Rotary Bushing

Forum is ready to deliver its Handling Tools according to the API 7K 6th edition.

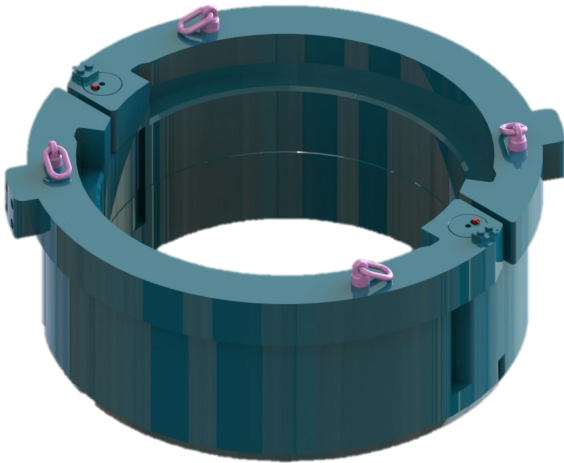
- Rotary bushings will be load-rated according to the API 7K standard
- Rotary bushings will be proof load tested to 1.5x the load rating according to the new API 7K standard. Rotary Bushings are exempt from proof load testing when loaded in compression only
- Marking of load rating and taper

- Handling tools purchased under prior effective API standards can be used "as is"
- An equipment upgrade from 5th to the 6th edition version might be possible in some cases, primarily for the B + V product line. A new load rating classification may be necessary. Please contact Forum for information on detailed upgrade options
- Spare Parts and Service for equipment in operation and purchased under prior API 7K editions will be available. New part-numbers will be issued for new edition parts
- Additional API requirements will require extensive testing for the 7K equipment which may have an influence on the sales price
